Date: 02/27/03

Ref #: SR500LFE-01-VID

Title: TX-SR500B

Classification: Mandatory Service Bulletin

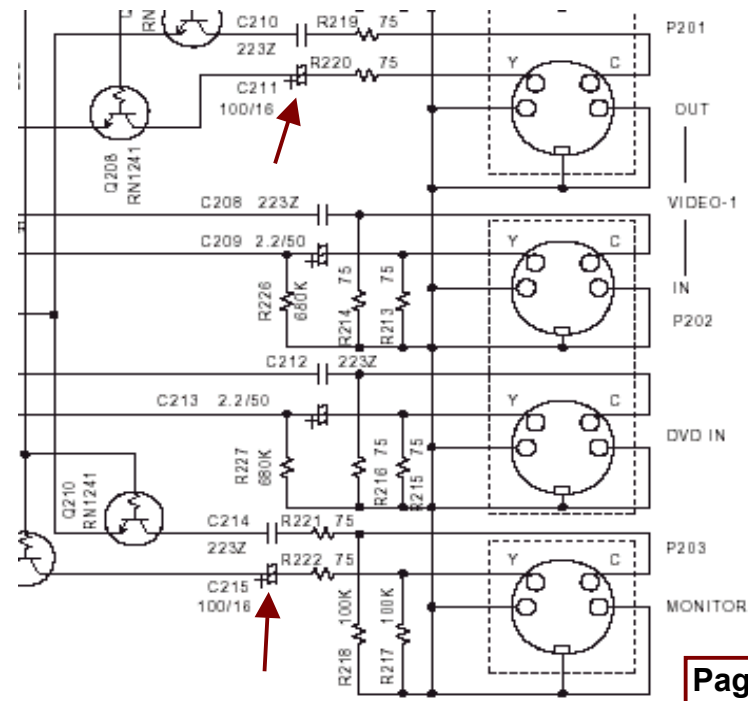
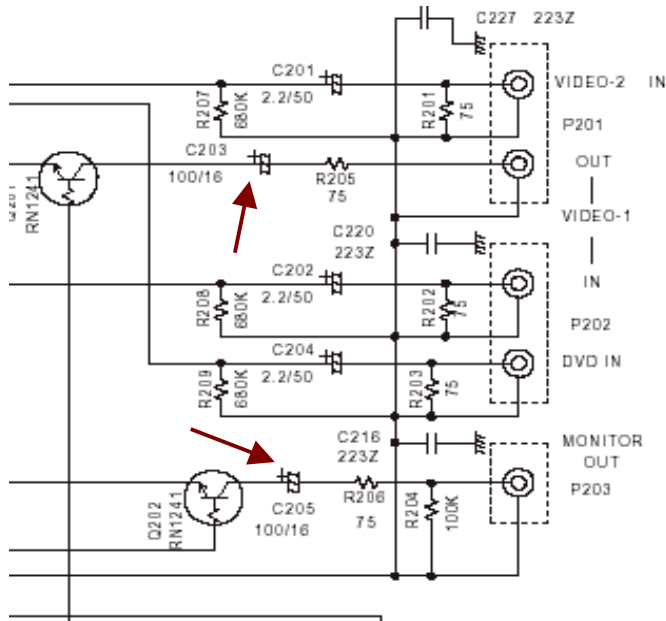
Symptom: 2) In production lower value of capacitors were used on PCB NAVD-7422, locations C C203, C205, C211, and C215 that may cause Video jitter, Vertical roll and Video mute in TV-Monitors.

Solution: 2) C203, C205, C211, and C215 must be changed from their current value of 47uf or 100uf to 1000uf. Please refer to page #2 bulletin "TR500-SR500-VID" for solution.

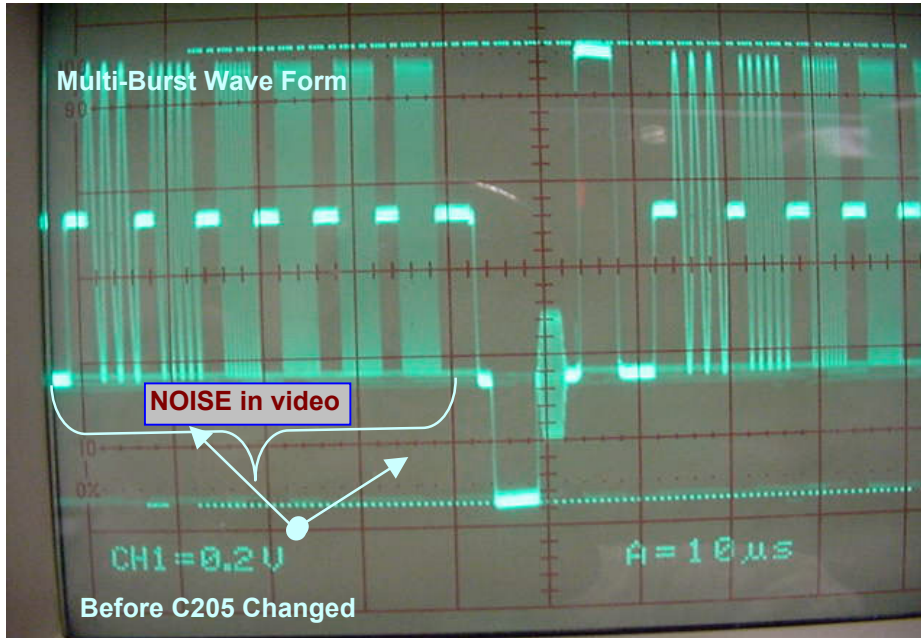
Problem: In some rare occasions, some TV-Monitors may experience Video Mute, Unusable Signal and Vertical Jumping video conditions when S-Video and Video is sent through receiver.

Solution: Replace C203, C205, C211, and C215 with 1000uf 6.3v capacitors. Part Number 354721029.

HT-R500 and TX-SR500 Disclosed information is only based on Composite Monitor Output. The change and modification will also apply to the S-Video Monitor Output as well.

In HT-R500 a change in C205 from its current value 100uf16V capacitor to 1000/6.3V will help eliminate the ringing and jitter in video waveform.
